XtremeAir GmbH, Harzstr.2, D-39444 Hecklingen Tel: +49 39267 60999 0, Fax: +49 39267 60999 20 www.xtremeair.de info@xtremeair.de	Document No. SB-XA42-2019-008
		Issue: B.00
DOA-Nr.: EASA.21J.360	Service Bulletin	Date: 04 DEC 2019

Subject:	Engine Mount Inspection
Aircraft models affected:	XA42 & XA41
Applicability:	Manufacturers serial numbers (MSN) 01 to 07 and 101 to 156 equipped with engine mount P/N XA42-7120-151
Compliance:	Mandatory, SB will be followed by an EASA AD
Time of Compliance:	1.) Initial visual inspection within the first 50 hours of operation of the engine mount or before the next flight 2.) Repetitive visual inspections after each 10 aerobatic flights*
Purpose:	To detect a potentially unsafe condition.
Background:	A crack was detected on an engine mount frame diagonal strut during a scheduled maintenance inspection. If not detected, the crack could grow and subsequent partial or complete failure of the structural joint possibly result in in-flight detachment of the engine and consequent loss of control of the aeroplane.
Manpower:	Approximately ten (10) minutes are required to perform each inspection
Materials:	An inspection mirror and a flashlight are required to

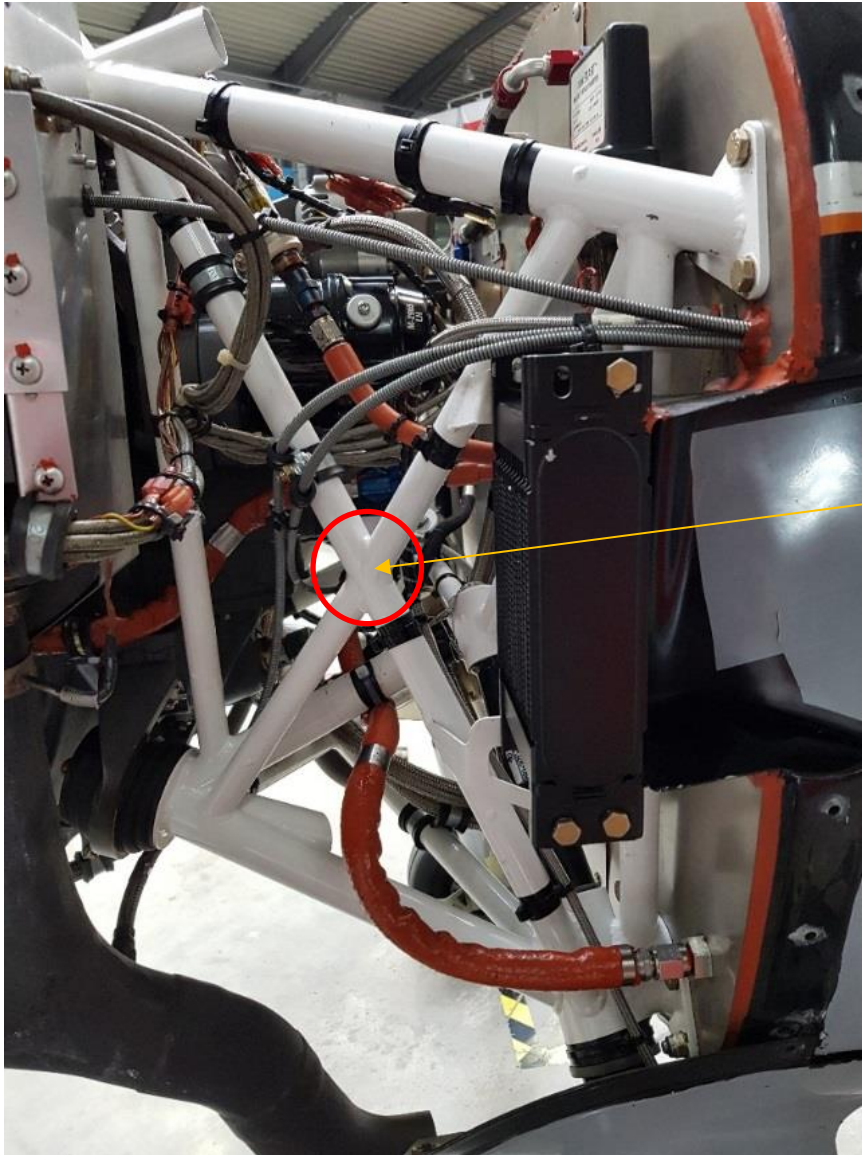
Accomplishment Instructions:	In addition to AFM chapter 4.3 section L, prior to the next flight and after each ten (10) aerobatic flights* thereafter, visually inspect the area of the junction of the L/H and R/H diagonal struts of the engine mount, forward of the oil cooler, for cracks. * each flight during which a load factor of 6 g is exceeded

LOOK FOR
CRACK HERE

If a crack exists, remove and replace the engine mount.
